UNITED STATES PATENT AND TRADEMARK OFFICE

APPLICATION NO.	FILING DATE	FIRST NAMED INVENTOR	ATTORNEY DOCKET NO.	CONFIRMATION NO.
10/757,819	01/15/2004	Fred J. Molz IV	MSDI-667/PC860.00	5404
52196	7590	01/26/2009	EXAMINER	
KRIEG DEVAULT LLP ONE INDIANA SQUARE, SUITE 2800 INDIANAPOLIS, IN 46204-2709			BLANCO, JAVIER G	
ART UNIT	PAPER NUMBER			
	3774			
MAIL DATE	DELIVERY MODE			
01/26/2009	PAPER

Office Action Summary	Application No.	Applicant(s)	
	10/757,819	MOLZ, FRED J.	
	Examiner	Art Unit	
	JAVIER G. BLANCO	3774

DETAILED ACTION

transitional surfaces and apertures (tool engaging elements) to receive projection portions (see representation of Figure 17 of Kohrs '631, below);

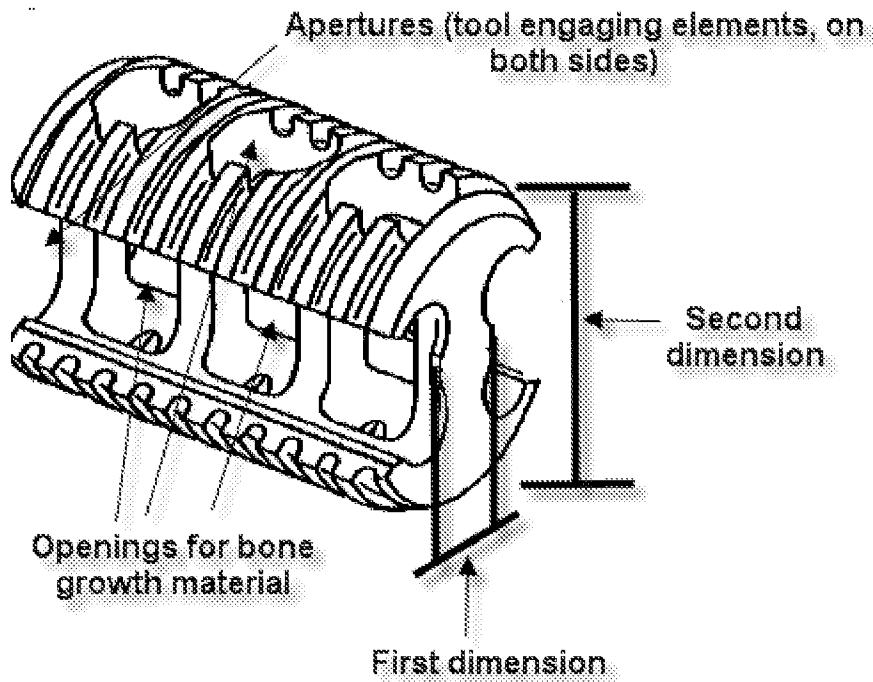
a. A device comprising a fusion cage (10) *adapted for insertion* into an intervertebral space between an adjacent pair of vertebral bodies, said device extending along a longitudinal axis and defining a primary transverse dimension and a secondary transverse dimension, said secondary transverse dimension *sized for insertion* into the intervertebral space, said primary transverse dimension sized greater than said secondary transverse dimension and corresponding to a select height of said intervertebral space, wherein the fusion cage further comprises rounded

c. An elongate member (Figure 17: elongate member 500, comprises a plurality of bone anchors 526, 527 and plate-shaped projection/interlock 506 comprising projection portions 523, 524) *sized to span* the intervertebral space and a plurality of bone anchors (526, 527) extending transversely from said elongate member and into engagement with the adjacent vertebral bodies. As seen in Figure 17, said spinal implant is engaged with said elongate member *to allow* selective rotation of said spinal implant relative to said elongate member about said longitudinal axis, said selective rotation of said spinal implant *serving to transition* said first transverse dimension to said second transverse dimension along said select height of the intervertebral space.

Regarding the limitation/clause “*to establish* said select height of the intervertebral space and *to maintain* said select height as said device is rotated/transitioned (e.g., the device is rotated, screwed, and/or manipulated during surgery) about said longitudinal axis *to align* said primary transverse dimension along said select height *to thereby provide* controlled compression of said device”, (i) it does not provide structure to the spinal construct, and (ii) it does not provide structural relationship between the fusion device and the “elongate member”.
